# **DEAGUE GROUP SUBMISSION TO CRAIGIEBURN WEST PSP AMENDMENT**

DECEMBER 2020

Figure 1. Key Plan - Summary of Submission items.

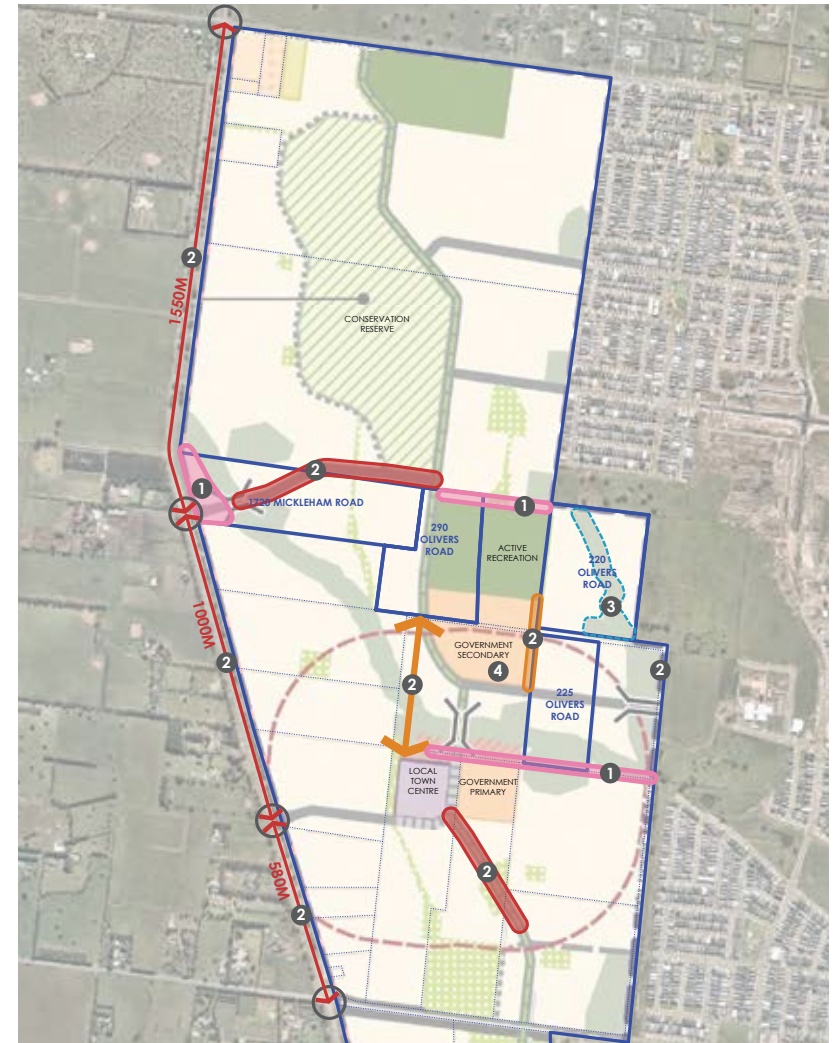
Review the layout of the AOS, waterway and roads to ensure that the PSP is not creating undevelopable land or an inefficient subdivision layout. Our proposed changes:

- Reduces the excessively large amount of land set aside for drainage purposes.
- Avoids creation of compromised land between Mickleham Road and the waterway.
- Creates a viable development area to the north of the AOS.
- Improves efficiency in lot layout by removing curved/diagonal roads where possible.

Review the size, extent and location of retarding basins to better align with the catchments and provide waterways where they are required and contribute to urban development.

Ensure the location of the active open space and school is best positioned to be service the largest walkable catchment and be delivered in the short term.

Review access to the sites to better reflect likely staging and removal of existing road access.

Figure 2. Recommended changes to Plan 4.

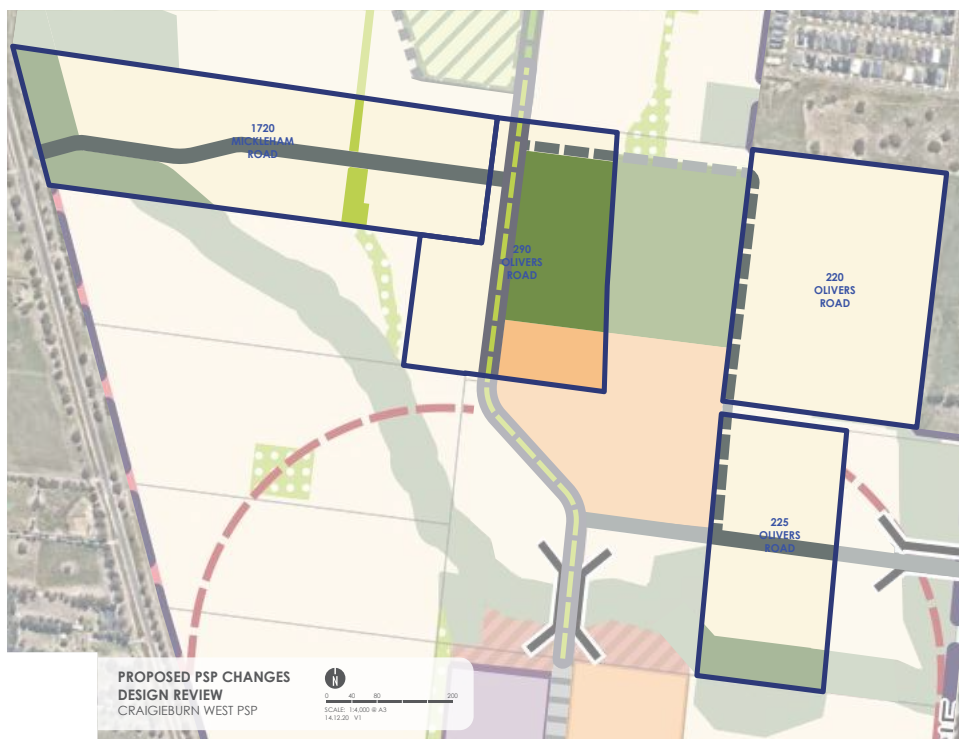
**Adequate lot depths** – Shift the AOS 15 metres to the south to enable the development of lots along the boundary of parcel 9. The positioning of the AOS in the PSP does not provide adequate space to provide for a local road along the boundary of the AOS and a row of lots. Shifting the AOS 15 metres to the south will resolve this issue as shown in Figure 3 below.

***Curved and Diagonal Roads*** – local and connector roads must be reviewed to create a more efficient lot layout and maximise views to natural assets as follows:

- Diagonal alignment south of the school and town centre straightened to seek improved subdivision outcomes.
- Potential for the connector intersection at Craigieburn Road to shift west and align with the park reserve road whilst still maintaining a 400m spacing. This would also mean the realignment to the north doesn't need to be so severe.
- Square the north south connector through property 14 to create a direct view line to the waterway and Town Centre, reduce extent of undevelopable land and improve lot layout.

***Review waterway width and alignments*** – review the location of the waterways so that they are not creating compromised land or cutting diagonally across properties. To improve land use and efficiency the following is recommended:

Locate the waterway along Mickleham Road as it passes through properties 7 and 6. This approach is beneficial in a number of ways by:

- Providing for a soft green frontage and will deliver the rural interface character sought by R4;
- Removing a difficult piece of residential land which would be wedged between a 6 lane arterial;
- Reduces frontage roads required along the waterway as well as loop roads to Mickleham Road frontage; and
- Allows for the culvert/bridge requirements to be determined and developed as part of the delivery in intersection IN-01.

Figure 5. Review of Drainage.

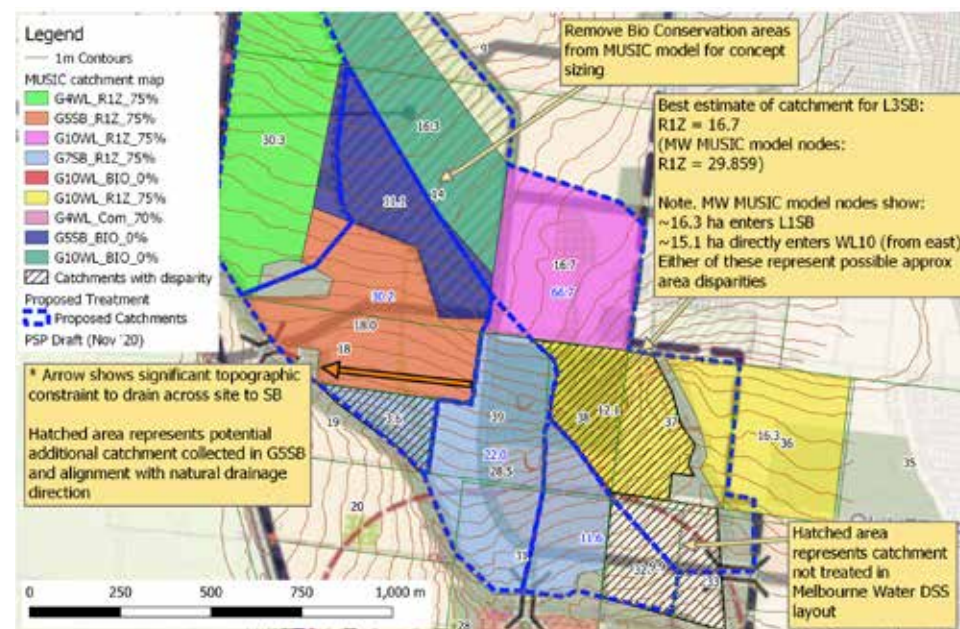
Afflux has prepared a plan which recommends improvements to be made to the waterway/wetlands to create improved drainage outcomes but which could also influence and improve the structure and functionality of the precinct. We make the following submissions based on detailed assessment of the drainage requirements by Afflux Consulting (also refer to Figure 5 and the Afflux Memo provided with this submission) with the following two major changes (and subsequent minor changes):

**G4 sediment basin and wetland** – should be relocated (west) to the Mickleham Road interface at the head of the waterway. There is no level change associated with this and it provides a more logical urban form. It will also meet the principal of discharging pipe into wetland and then into waterway.

- G5SB – is recommended to move further south depending on final Urban Structure to ensure it collects the full catchment and creates a better relationship with the urban form. The current location has very little catchment with potentially only 18 hectares of residential land draining into it, shifting it south would improve its catchment. Ideally this basin is moved far enough south to collect flows from the proposed north south collector road and/or combining with G7SB.

- G7SB – Relocate to the end of the North-South connector road. This road link is assumed to be a major overland flow path and represents a significant topographic consideration when selecting sediment basin location. The catchment for G7SB is indicated in the Melbourne Water MUSIC to collect 29.859 ha (RES). However, Afflux has reviewed the model and expects that this catchment may have already been counted for treatment in G5SB catchment or L3SB (if Pipe N1 drains east toward L3SB). The proposed catchment and relocation will provide for better drainage outcomes due to topography and represents a much more logical asset positioning.

- G8WL – move south of geomorphic feature and abutting recreation fields. Placing a wetland across two land parcels creates future conflicts and delivery issues. The waterway should sit on MW parcel 32, and the wetland on parcel 30.

**Remove the north-south Waterway tributary** – The north south tributary construction is a high risk engineering proposal, that does not meet with MW's own sodic soil recommendations. The flows from this catchment have been incorrectly calculated and do not meet the hydraulic criteria for a waterway. The 45m corridor does not provide for either a headwater stream or a piped, highly engineered waterway, and either should be reduced in scope or completely removed and a piped option considered.

- Swales – the use of swales and green roads ought to be considered as a viable alternative to overland flow conveyance given the lower flows found in the RORB review (~6 m³/s split over two swales and pipes). In our view, the flows here do not justify a 40-45m waterway and particularly one which has high risk sub-surface soils with high risk for future failure such as this (as per Jacobs' report findings, source: MW email 21/11/2020). Moreover, swales require less cut (as compared to constructed waterways) and therefore reduce possibility of soil failure expected in locations with steep slope that would provide a safe alternative for overland flow conveyance.

- L1SB – Shift to south and combine into the G10WL for better catchment efficiency. As with G5SB the sediment pond catchments should be maximised to reduce Council/MW assets. If the north south waterway is removed, there is no need for this basin here and it would be better placed with the wetland system.

- L3SB – reconfigure to align with overland flow path and consider its relocation in conjunction with RORB and waterway conveyance review.
- G10WL – Wetland configuration requires review noting that This asset does not collect flows from DFWS property 32 or 33, leaving those flows untreated. The wetland is located on area of high grade and will be of high engineering risk. A more east west alignment, rather than north south would be a better arrangement.

**Recommendation:** Adopt the recommendations of the Afflux work in the PSP Urban Structure, and require MW to undertake detailed further modelling.

**Figure 7.** Catchment Analysis showing overlapping catchments.

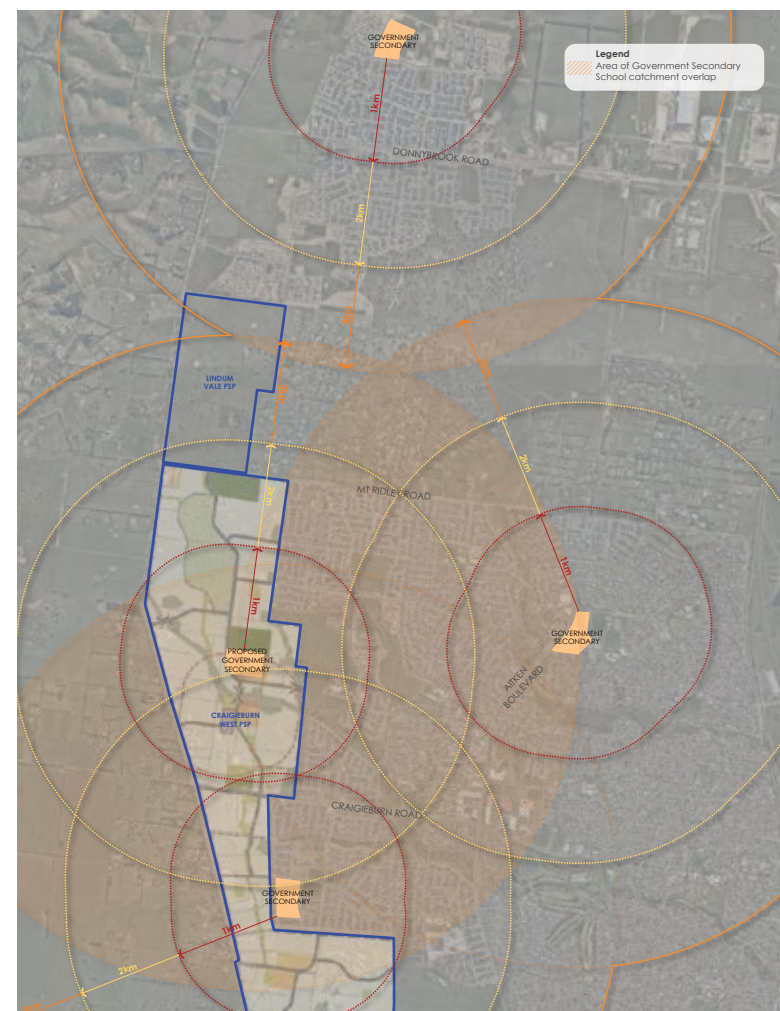
Whilst the PSP benchmark is for homes should be within 3.2km of a secondary school, we view this as a low threshold which could readily be achieved in PSPs. The location of secondary schools should seek to capture the largest walkable/cycling catchment possible and avoid overlapping catchments. Given the elongated shape of the PSP, it is inevitable that some overlapping catchments will be created, but it is our submission that this should be minimised. The location of the secondary school on the draft Place Based Plan creates overlapping catchments (within 1km and 2km) with existing secondary schools in Craigieburn, and leaves the majority of the Lindum Vale PSP area to the north (which has no community/education facilities) outside a 2km catchment. We believe that the planning of facilities in this PSP should have consideration for the wider context and the catchments for the facilities and the Place Based Plan could improve in this regard.

- VPA to consider the catchments for the AOS and Secondary School and whether the Place Based Plan ought to be reviewed to reduce overlapping catchments.
- VPA and DET to provide confirmation that the location of the secondary school across 4 property titles will not pose an impediment to its early acquisition.
